Confidence Texwear Ltd.

8th February 2021

Buildings Information

Observations

Columns are stressed above normal design limit

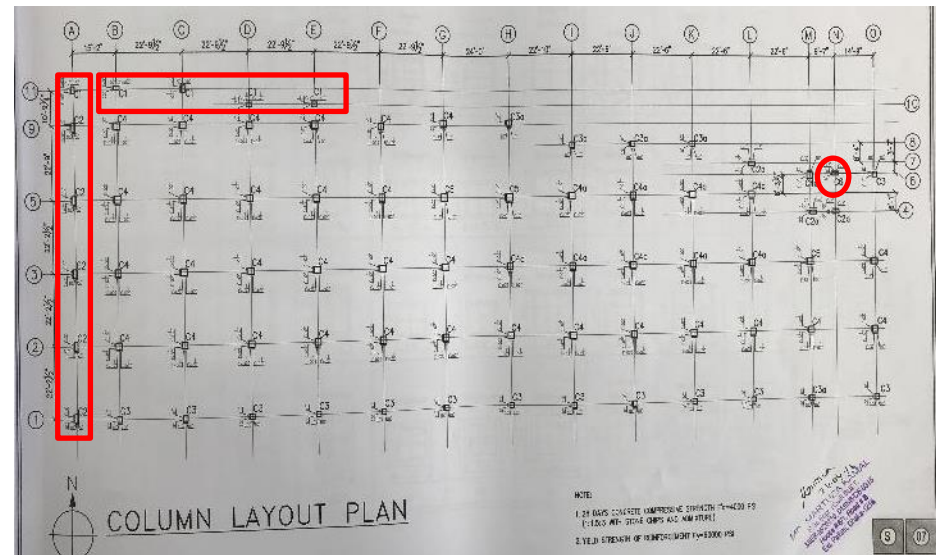
Cursory calculation indicates that columns are stressed above normal design limit considering prepared live load plan and minimum concrete strength value from aggregate type. Building engineer is required to review design, load & column stress.

Ground floor height is 5300 mm, least dimension of some columns are 300 mm (C7), 375 mm (C1,C2). Building engineer is required check the slenderness effect of the columns.
